UNITED STATES PATENT AND TRADEMARK OFFICE

APPLICATION NO.	FILING DATE	FIRST NAMED INVENTOR	ATTORNEY DOCKET NO.	CONFIRMATION NO.
10/681,019	10/08/2003	Mikio Oda	14356Z	6178
23389	7590	02/07/2006	EXAMINER	
SCULLY SCOTT MURPHY & PRESSER, PC 400 GARDEN CITY PLAZA SUITE 300 GARDEN CITY, NY 11530			STAHL, MICHAEL J	
			ART UNIT	PAPER NUMBER
			2874

Office Action Summary	Application No. 10/681,019	Applicant(s) ODA ET AL.	
	Examiner Mike Stahl	Art Unit 2874

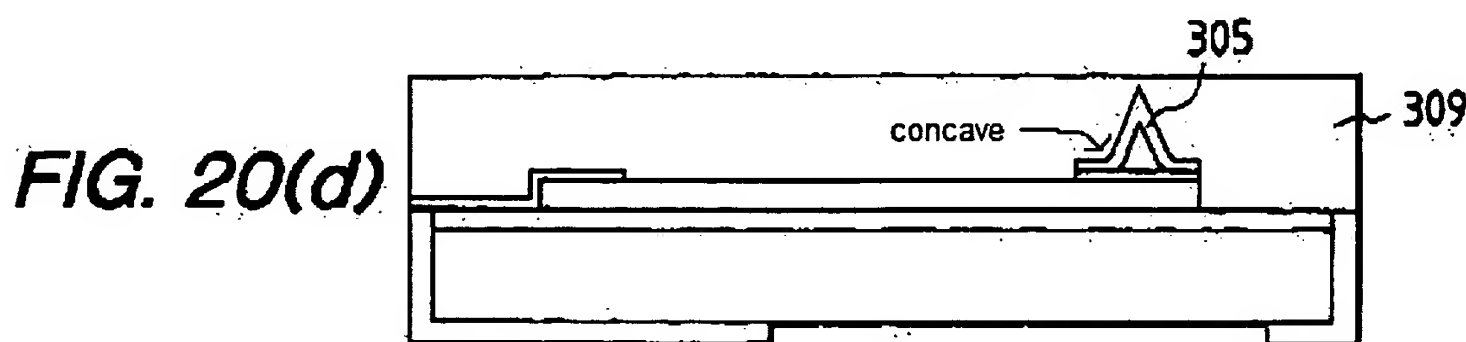
Finally the remarks argue that Shimada '637 shows a convex portion, not its concave portion, surrounded by polyimide 309 (fig. 20(d)). However, the polyimide layer does fill a concave portion of the mirror. See the annotated figure below for a clarification of the examiner's interpretation:

The region labeled “concave” is a concave portion of the mirror, so the polyimide layer 309 is seen to fill a concave portion of the mirror as claimed. The *interior* of the mirror, that is, the portion inside the apex angle of the triangle or pyramid, is not filled with the polyimide material (but is otherwise considered to be filled with air). If applicant amended the claims to further point out the triangular or pyramidal structure of the mirror, and to recite that the concave portion inside the apex angle thereof is filled with a solid material, this may be helpful to distinguish the invention from the applied references.
